# Service Information

Category <b>N</b>	<b>Repair Guidance</b>	Ref. No. R102/16D	Page 1 of 4
Coverage <input type="checkbox"/> Distributor only <input checked="" type="checkbox"/> Please inform your dealers		Date Issued November 25, 2016	
Please convey this information to your <input type="checkbox"/> Director <input checked="" type="checkbox"/> General Manager <input checked="" type="checkbox"/> Warranty Dept. <input checked="" type="checkbox"/> Parts Dept. <input checked="" type="checkbox"/> Training Dept. <input checked="" type="checkbox"/> Field Rep.		Date Revised November 28, 2017	
Applicable Model Mazda6 (GJ/GL), Mazda3 (BM), CX-3 (DK) , CX-5 (KE) and Mazda2 (DJ), with Leather Steering Wheel		Applicable Countries and/or Vehicle Specifications  Europe

## Subject: Wear/Peel off of Leather Steering Wheel Surface

Problem sample photos: Mazda6 (GJ)

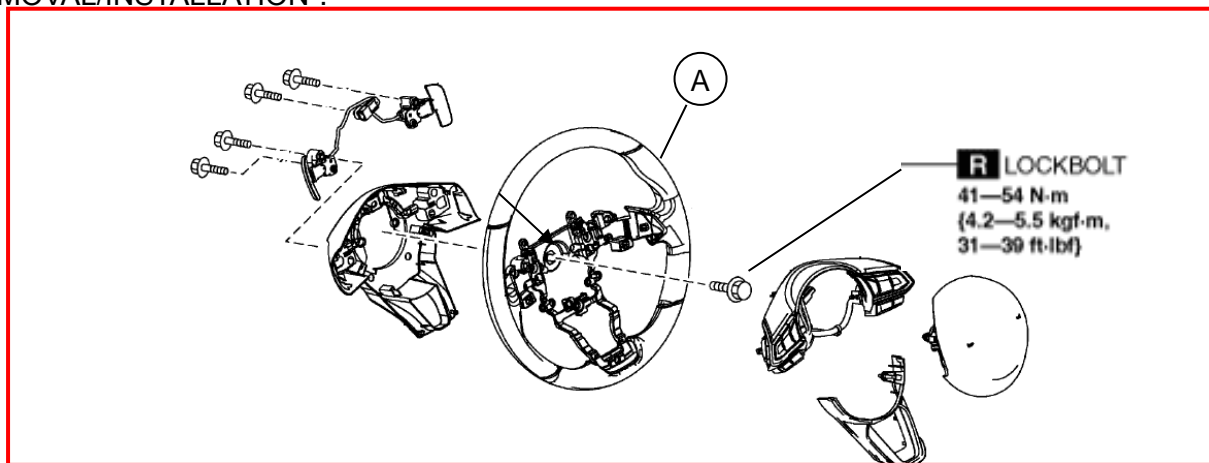
Some vehicles may exhibit wear/peel-off of the leather steering wheel surface causing a poor appearance.

This concern is caused by an insufficient wear resistance of the steering wheel surface.

For Mazda6 (GJ), Mazda3 (BM), and CX-5 (KE), the mass-productions have been discontinued. For, Mazda6 (GL), Mazda2 (DJ) and CX-3 (DK), the wear-resistance of the steering wheel has been improved.

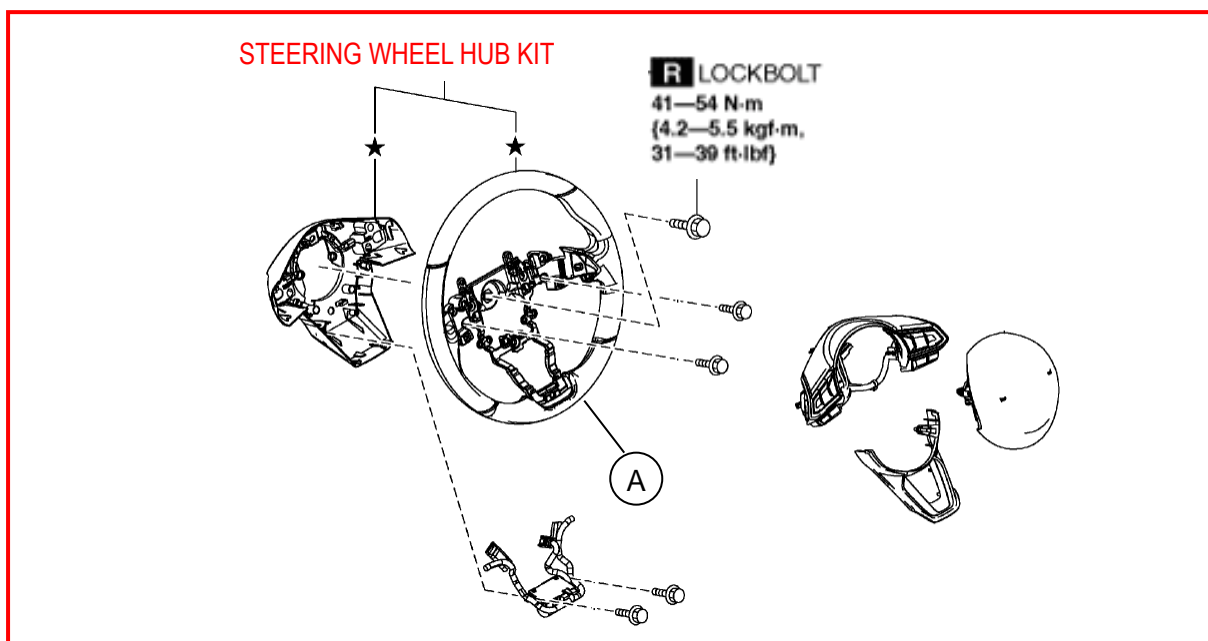
When you receive a customer complaint on this concern and the symptom can be confirmed on the vehicle, replace the steering wheel (A) by a modified **one** with improved wear-resistance according to the workshop manual "STEERING WHEEL AND COLUMN REMOVAL/INSTALLATION".

**NOTE:** For steering wheels with STG. wheel warmer, replace steering wheel hub kit.
